NEI 99-02 FAQ 20-05
RBS Unplanned Scram May 2019

Plant: River Bend Station, Unit 1
Date of Event: 5/31/2019
Submittal Date: October 09, 2020
Licensee contact: Timothy Schenk Tel/email: 225-381-4177 / tschenk@entergy.com
NRC Contact: Raymond Kumana Tel/email: 817-200-1970 / rkuma94@entergy.com

Performance Indicator: IE04 - Unplanned Scrams with Complications (USwC)

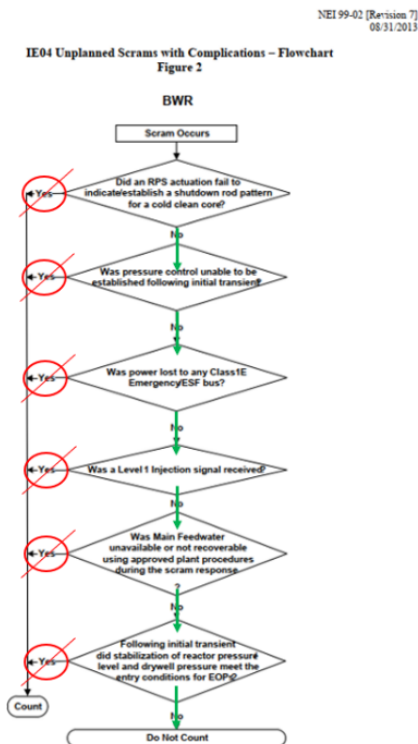
Based upon the above timeline and NEI 99-02 Rev. 7 definitions, RBS was outside the "Scram Response Time" by 30 minutes before the subsequent level three scram signal and therefore did not have an Unplanned Scram with Complications. Additionally, the below flowchart demonstrates this conclusion as seen in NEI 99-02 Rev.7, Figure 2.

The resident inspectors believe the May 31, 2019 scram is an unplanned scram with complications based on answering “Yes” to NEI 99-01 Revision 7, “IE04 Unplanned Scrams with Complications – Flowchart” questions #5 and #6.

On Question #5, “Was main feedwater unavailable or not recoverable using approved plant procedures during the scram response”, the resident believes the answer is “Yes.” The resident takes the word “recoverable” in the sentence to mean recoverable in a sustainable manner. Main feedwater was not recoverable in a sustainable manner using approved plant procedures because approved plant procedures did not instruct operators to un-isolate the heater string when bringing the feed pump back online. In using approved plant procedures, operators failed to un-isolate the heater string during their initial start of the feed pump. Consequently, when they secured the condensate pump per procedure, they caused the feed pump to trip, resulting in a low-level scram signal and an EOP re-entry.

The guidance clearly indicates that the scope of the question includes the period after the plant has been initially stabilized and EOP's have been exited, where operators are stabilizing the remainder of the plant to allow for the use of normal operating procedures. The station was in that period when the second EOP entry occurred. Due to the abnormal feed system lineup that the station implemented during the initial response and stabilization, an abnormal condition developed in a scram response related vessel parameter—specifically, reactor vessel level—that required re-entry into EOPs.

Should be "NO" provided that the main FW system was available for use within an estimated 30 minutes of the event.

Should be "NO" since all Scram Response criteria were met within 11 minutes of the initial scram and was being maintained in a stable condition for the duration of the event. Therefore, the reactor was never considered to be in an unstable condition.
